June 2021 Product Shipping Configuration Change Notice For Poly CCX and Trio Series

Engineering Advisory 206112

June 2021 | 3725-47164-001B

CCX Console Label and Revision Code

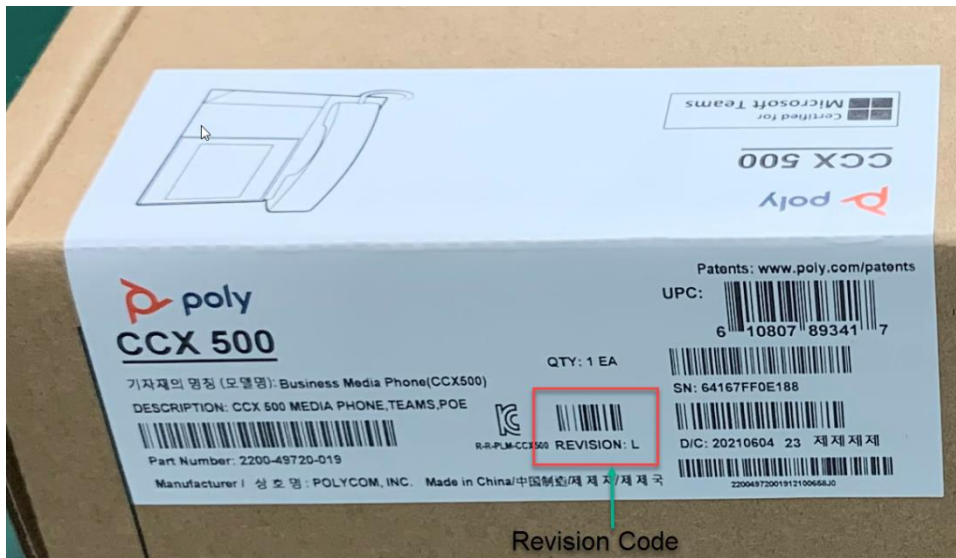
You can determine whether your phone includes the new software by examining the date code listed on back of the phone and on the shipping boxes, as shown in the following two example figures [CCX/Trio Console Label and Revision Code](#) and [CCX/Trio Shipping Box Label and Revision Code](#). This notice will be updated to reflect the actual codes as information becomes available.

Note that in the two figures the date code starts with the following Chinese characters 生产日期 followed by the date code format YYYYMMDDLL, indicating when the phone was built. (The suffix LL indicates the manufacture location.)
